## ESSEX JUNCTION STP 5300(13) – CRESCENT CONNECTOR

December 19, 2022

ADDENDUM #1 - This addendum provides the following:

ORNAMENTAL TRAFFIC SIGNAL POLE FOR THE CITY OF ESSEX JUNCTION, VERMONT

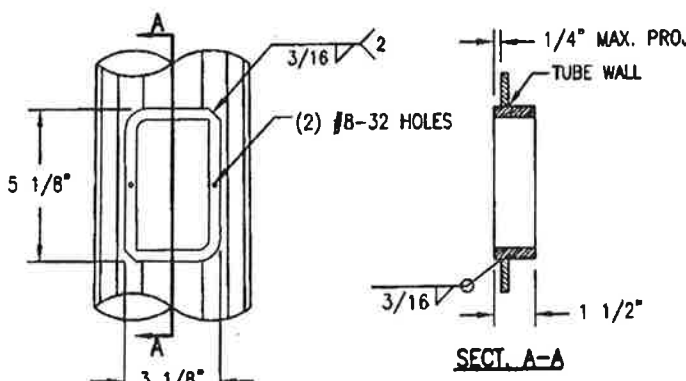
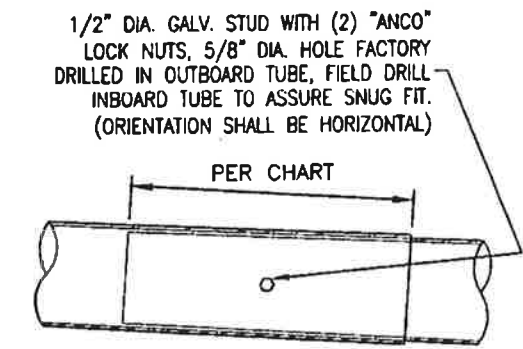
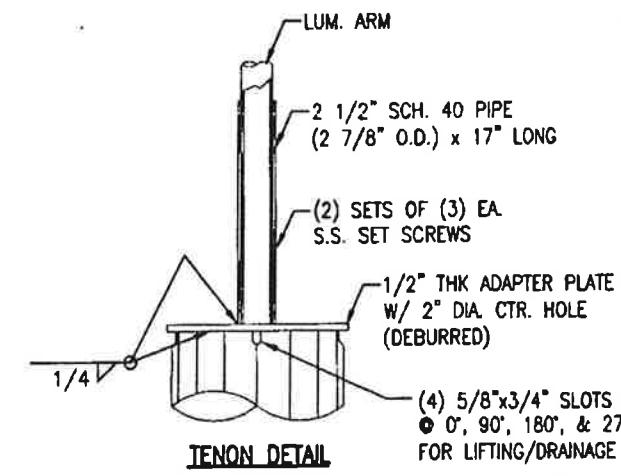
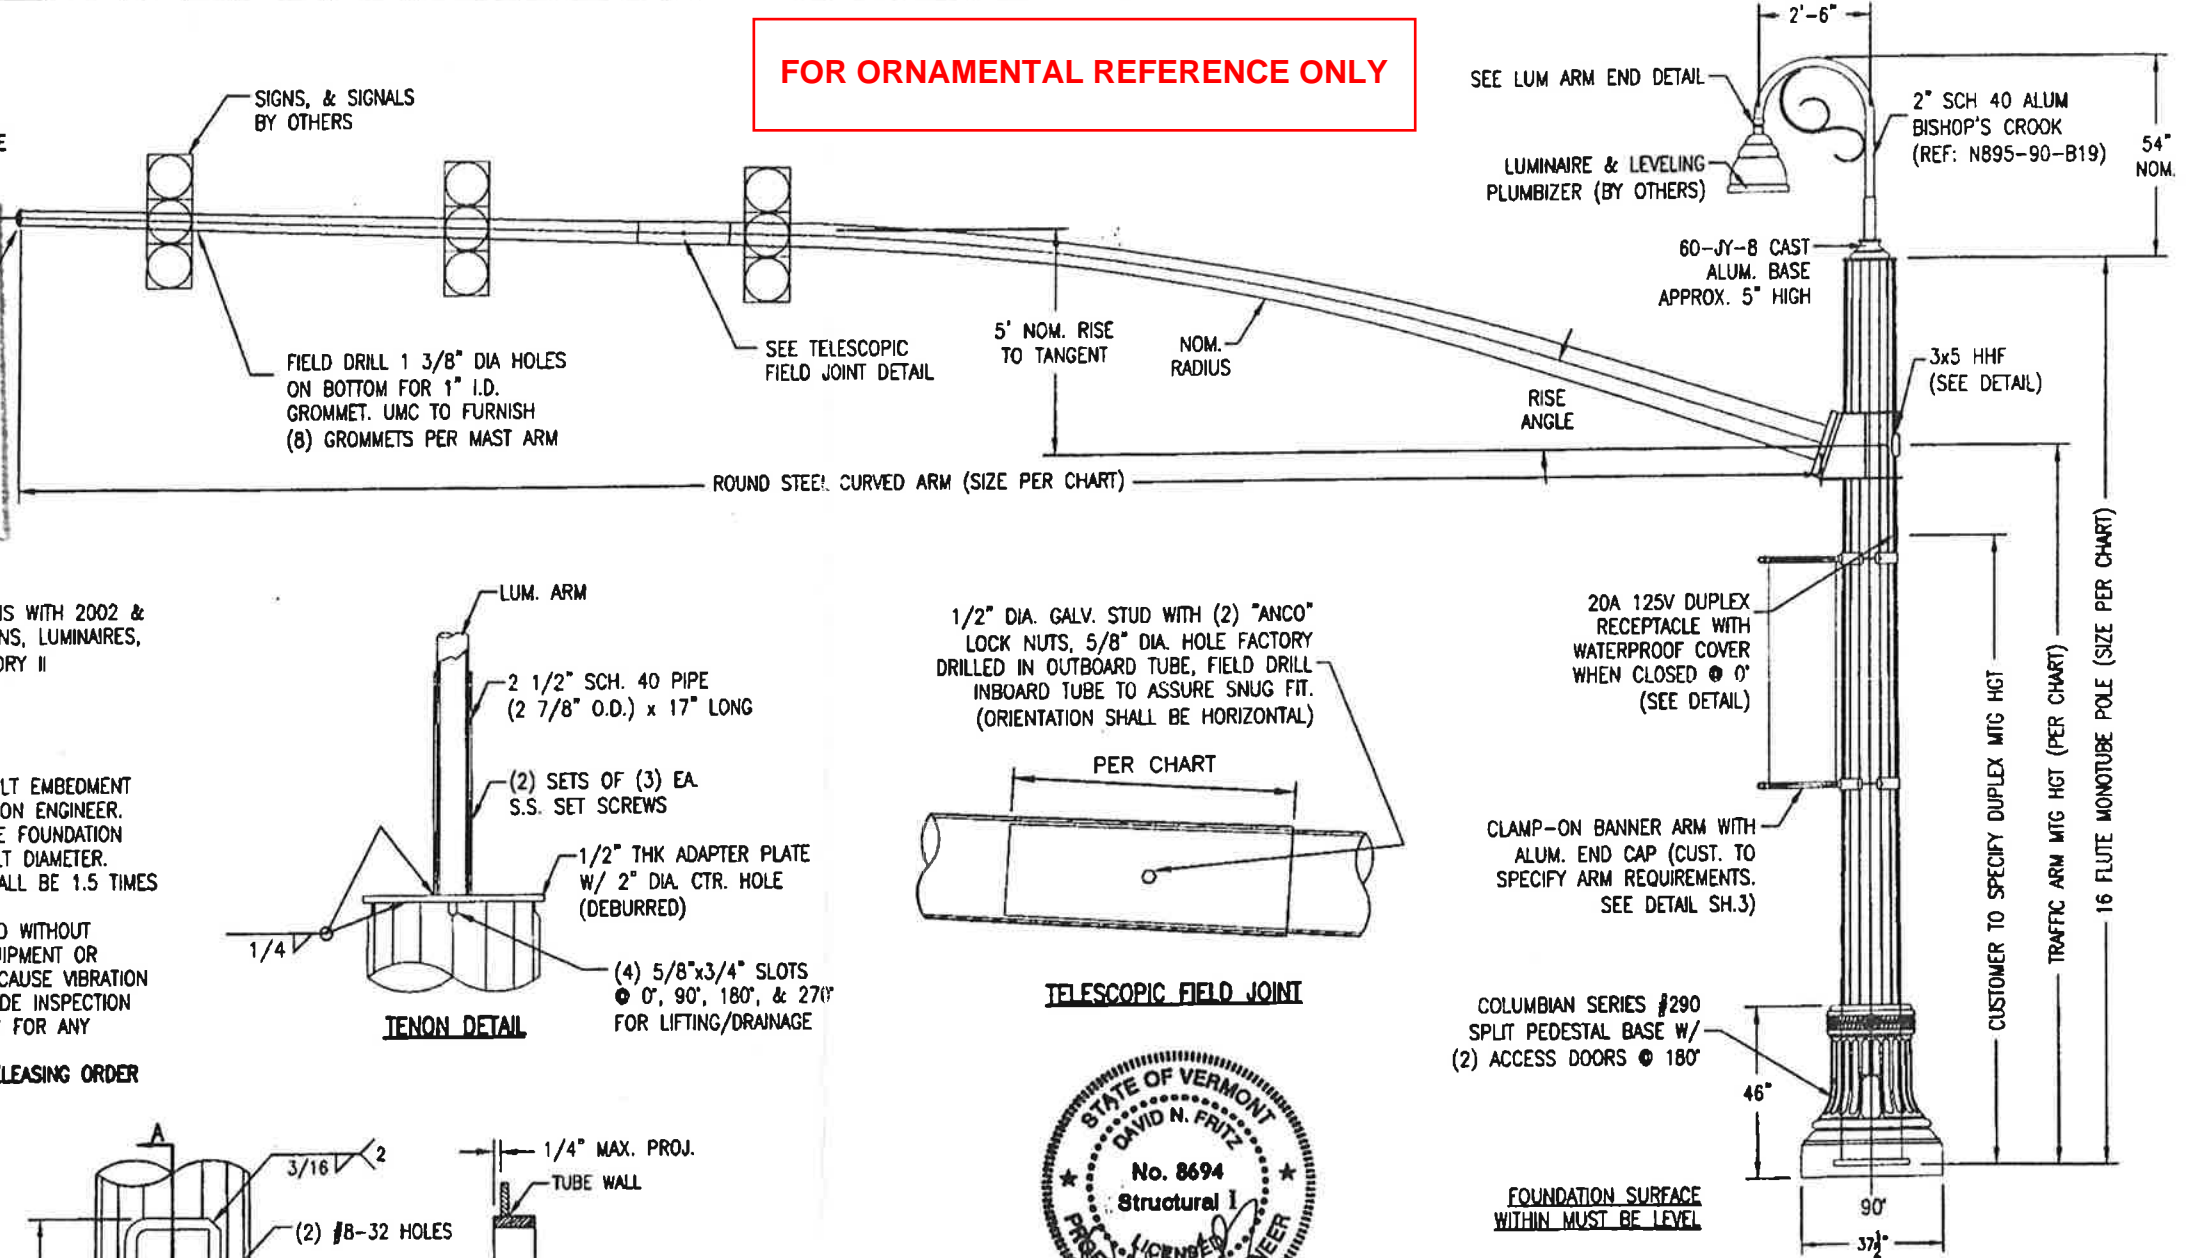
does not match sheet 23

does not match drawing
